NORTH ANNA POWER STATION, UNIT NO. 1

AMENDMENT TO FACILITY OPERATING LICENSE

Amendment No. 78
License No. NPF-4

ATTACHMENT TO LICENSE AMENDMENT NO. 78

Figure 6.2-1 Offsite Organization for Facility Management and Technical Support

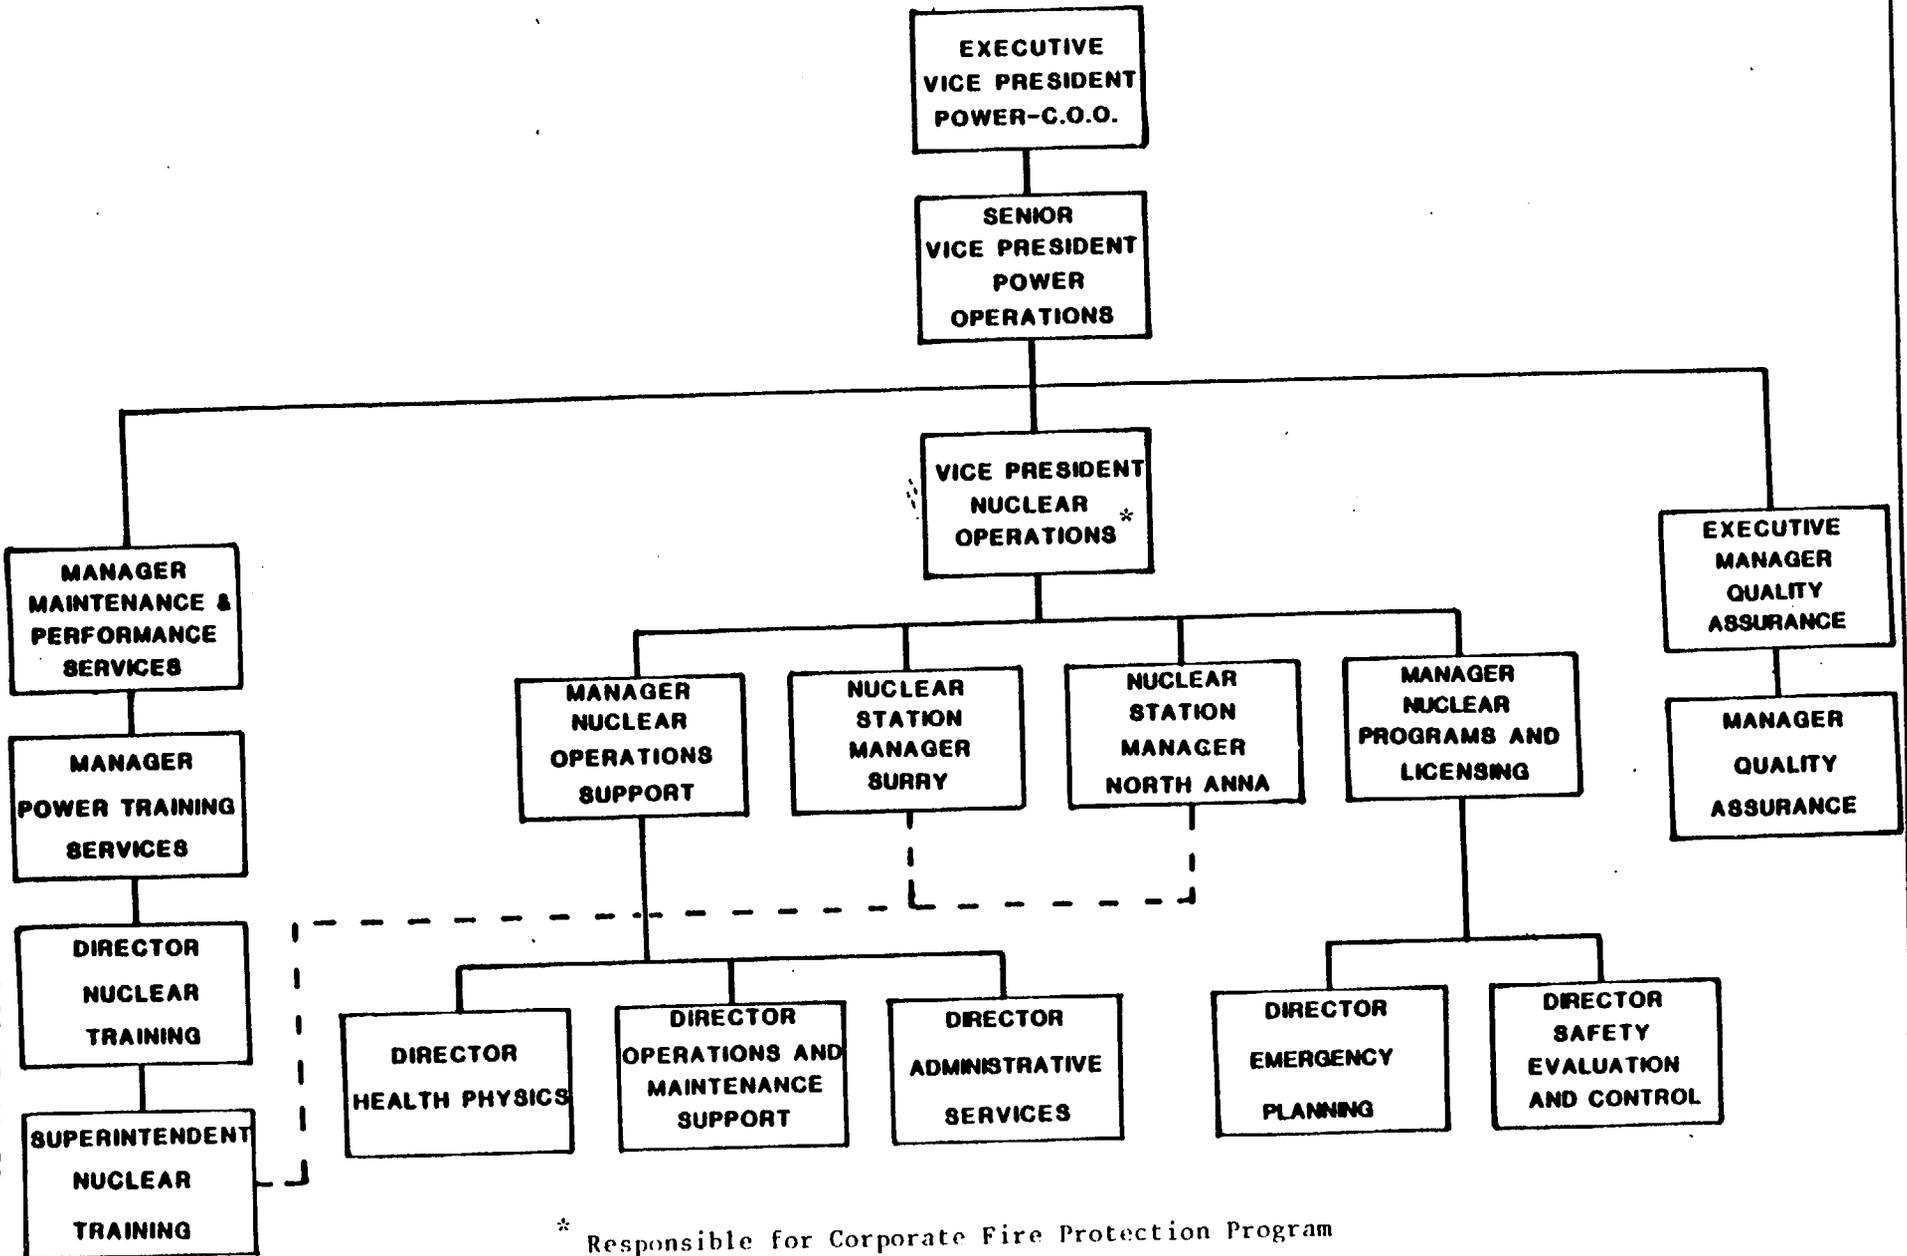
The licensee proposed changes to the TS to reflect recent reorganization changes in the Nuclear Operations Department. Organization figures 6.2-1 and 6.2-2 were revised to show the structure of the new organization. The most significant change involved the creation of the Manager, Nuclear Programs and Licensing, and the Assistant Station Manager (Nuclear Safety and Licensing). Otherwise, several changes were made to titles, responsibilities, and reporting requirements. The proposed change is administrative in nature and does not involve a reduction in organizational effectiveness.

6.2.1 The offsite organization for facility management and technical support shall be as shown on Figure 6.2-1.
